Road Safety Audit
Stage 1/2
for
ACCESS TO PROPOSED MIXED USE DEVELOPMENT
AT
CARRIGALINE, CO CORK

Reference: RSM/MOB/121021/CARRIGALINE RSA1-2

Client	HLCE Limited
Project Title	Access to Mixed Use Development, Carrigaline, Co Cork
Document Title	Stage 1/2 Road Safety Audit
Document Ref.	RSM/MOB/121021/CARRIGALINE RSA1-2
Status	FINAL

Figure 3: Collision Plot for Road network adjacent to site

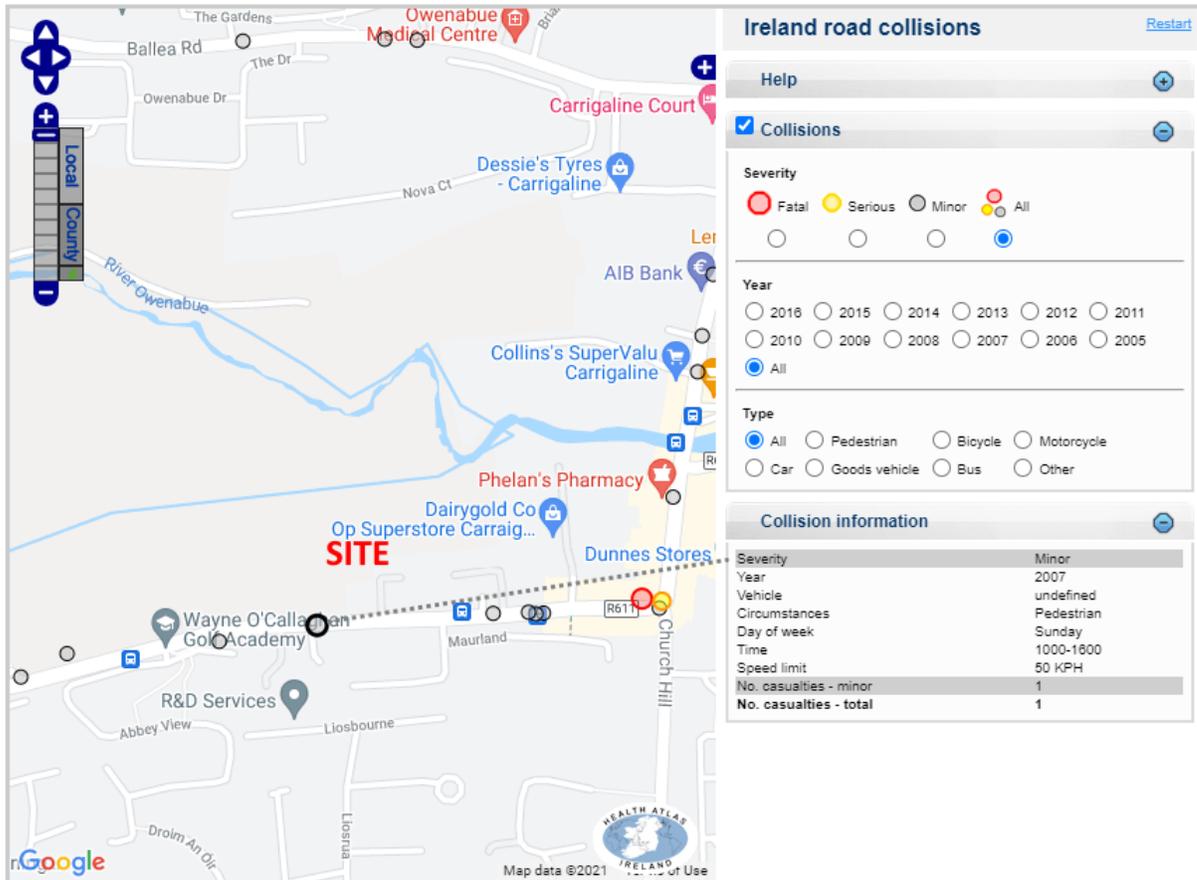
- 2.1.3 No information was provided on any existing collision statistics in the vicinity of the site. A review of the Road Safety Authority (RSA) online collision database indicates that there were a significant number of collisions recorded on the R611 Kilmoney Road Lower to the south of the site between 2005 and 2016 inclusive, as shown in figure 3, a high proportion of which involved Vulnerable Road Users (VRUs, including pedestrians, cyclists and motorcyclists). A collision involving a pedestrian was recorded at the location of the new intersection with the proposed CWRR, which is located at the southwestern corner of the site, and will be used by a high proportion of vehicles to access the site. An Audit of this junction was outside the scope of this Stage 1/2 RSA, however the safety of all road users should be considered in accessing the site from all directions, particularly in the context of the site location within an urban environment, where a high proportion of VRUs should be anticipated.

It should be noted that the RSA database is not a comprehensive record of collisions, and does not include damage only collisions or any collisions recorded since 2016 (or before 2005), hence should be reviewed in conjunction with the Local Authority / Gardaí records for the network surrounding the site.

Figure 7: Levels and details unknown in Public Amenity Area

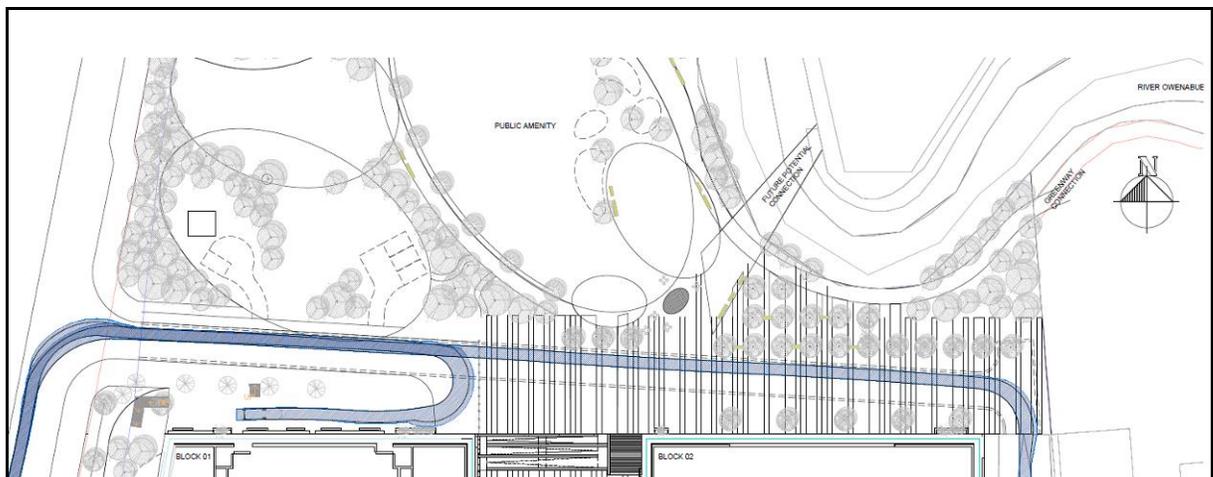
There were no long or cross sections provided for the proposed roads. A large portion of the northern section of the site will be used for public amenity, adjacent to the River Owenabue, however there were no details provided for proposed surfaces and gradients on footways and VRU routes to determine suitability for all road users, including those who are mobility or visually impaired.

1. Detailed design should include vertical design and long and cross sections, and provision should be made for a relatively level dwell area at the proposed site access for a distance of 15m back from the channel line.
2. Detailed design should include details of any proposed embankments along the western site perimeter, and details of all gradients and crossfalls on roads and surfaces to be used by traffic and VRUs, including within the public amenity area at the north of the site.

2.1.6	Yes	Yes	These issues will be address at detail design stage prior to tender issue.	
2.1.7	Yes	Yes	These issues will be address at detail design stage prior to tender issue.

Figure 11: Proposed Ramps and steps within Site

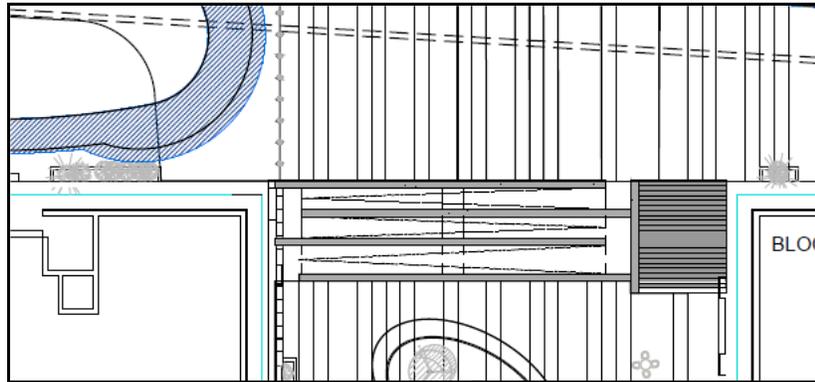
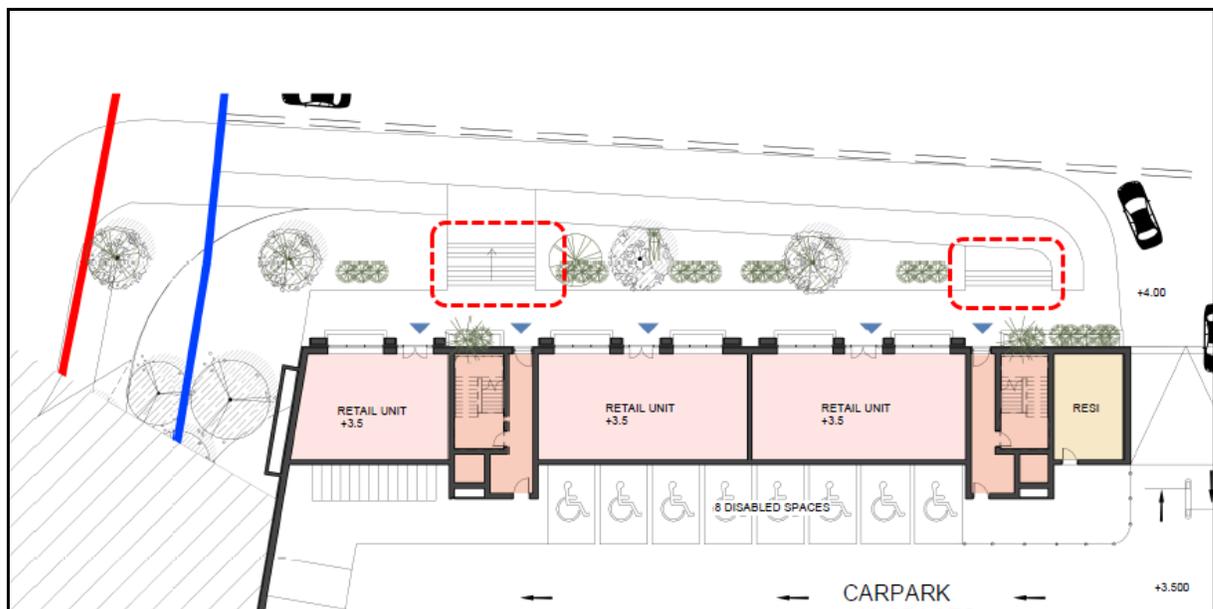
2.3.1.2 Ramps and steps have been shown at a number of locations within the site, however details have not been provided for ramps to ensure widths and gradients are suitable for all anticipated road users. Tactile paving has not been shown to the top and bottom of steps to alert visually impaired pedestrians to the presence of the hazard.

1. All ramps throughout the scheme should have a maximum gradient of 1:20 (preferable) or 1:12 (absolute maximum over short distances only) at all locations. An alternative means of access for wheelchair users must be provided in all locations where steps have

been provided and where there is no ramp, or where ramp gradients of 1:20 or greater are provided, with a total ramp rise greater than 2m.

2. Ramp widths and layout should comply with the requirement of Technical Guidance Document M, Access and Use (2010) with the minimum unobstructed width between handrails to be not less than 1200 mm, and 1500mm between the walls, with wider ramps to be provided for shared use with cyclists, or where a high demand for access by buggy/double buggy users may arise.
3. Corduroy tactile paving should be provided at the top and bottom of all steps throughout the site and configured in accordance with 'Guidance on the use of Tactile Paving Surfaces'.

2.3.1.2	Yes	Yes	These issues will be address at detail design stage prior to tender issue.	
2.3.1.3	Yes	Yes	These issues will be address at detail design stage prior to tender issue.	
2.3.1.4	Yes	Yes	These issues will be address at detail design stage prior to tender issue.	
2.3.2	Yes	Yes	These issues will be address at detail design stage prior to tender issue.	
2.4.1	Yes	Yes	A public lighting design has been prepared as part of the planning application..	
2.4.2	Yes	Yes	A detail schedule of signage and road marking will be produced at detail design stage prior to tender.

Figure 13: Vehicular Movements on Pedestrian Access

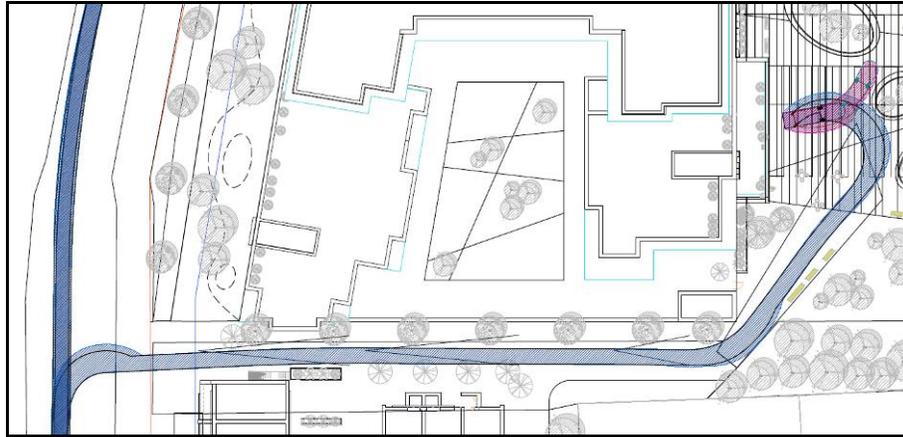
2.3.1.3 A pedestrian access has been shown at the southern section of the site which includes ramps and steps, however swept path analysis has been provided to demonstrate vehicular access at this location also, where conflict may arise. Pedestrians are also likely to be circulating within the access route to and from the delivery area to the east of the site, where conflicts may also arise, particularly as HGVs have limited visibility and blind spots.

1. Pedestrian movements should be segregated from HGV and vehicular movements where possible throughout the site.
2. All routes to be used by vehicles should have suitable gradients, and provision should be made for suitable dropped kerbs where necessary at all locations where vehicular access is required, including for emergency vehicle access, with clear signage for the latter to ensure routes are not obstructed by other vehicles.

Figure 14: Details for Greenway Connection & Cyclist Connectivity Not known

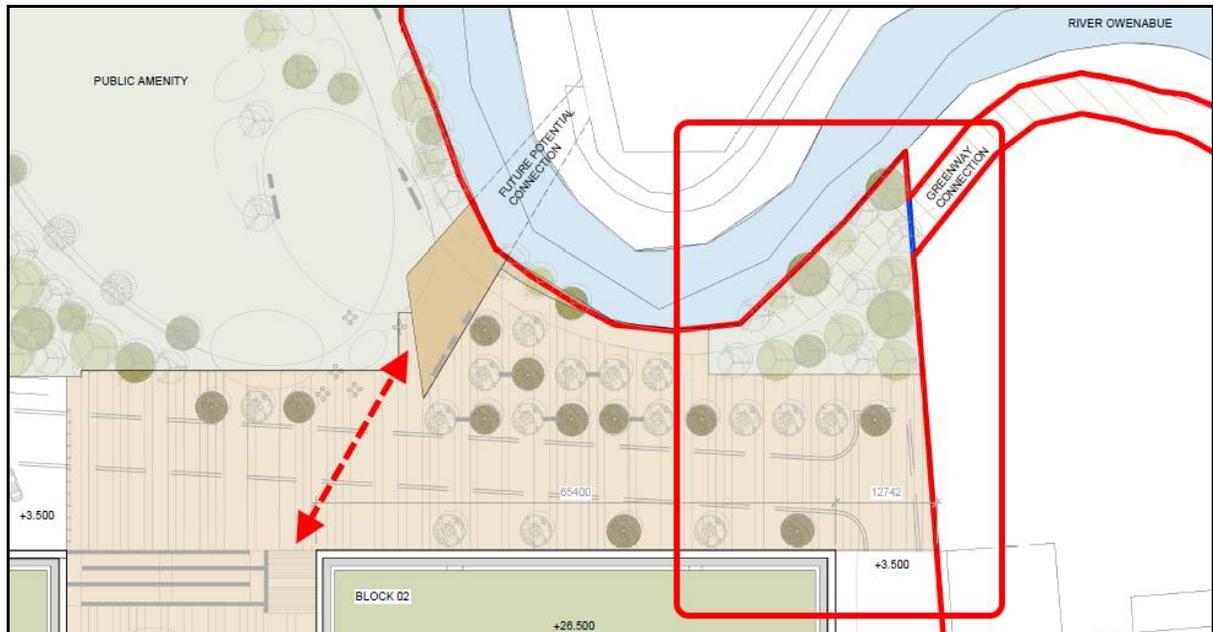
No information has been provided on likely cyclist demand and activity to and from the site, and there was no cycling activity observed adjacent to the site at the time of the site visit. The design includes provision for a significant number of cycling parking spaces, however the proposed routes to and from the bicycle parking areas are unclear. There are no dedicated cycling routes or facilities shown, and cyclists would be expected to share road space with motorised vehicles where the risk of conflict is higher. The widths of the proposed footways throughout the site and surrounding the site are insufficiently wide for

shared use between cyclists and pedestrians. The layout plans show provision for a Greenway connection to the northeast side of the site along the southern bank of the river, however there is no provision for connectivity to the hard surface areas. Cyclists will also be brought out into an area where vehicles will be reversing and turning, as a turning head has been shown, as indicted on figure 14. Future potential connection over the river has also been shown, however it is unclear how cyclists will access the southern section of the site as the ramp width shown in figure 4 immediately west of the steps appears too narrow.

1. Likely cyclist demands, desire lines and volumes should be examined within and on all approaches to the site to take into account issues raised in this Stage 1/2 RSA report, with safe continuous and unobstructed facilities provided to cater for anticipated cycling demands, inclusive of shared off road facilities wherever possible, with a minimum 3m width, to minimise the risk of pedestrian and cyclist conflict.
2. Provision should be made for suitable transition kerbs to facilitate safe access between on and off-road facilities and proposed bicycle parking spaces within the site, and gradients on all routes to be used by cyclists should be a maximum 3%.

3. Detailed design should include provision for suitable connectivity to the Greenway and proposed cycling network long the CWRR. Cyclists should not be brought out into areas where vehicles will be turning and reversing.
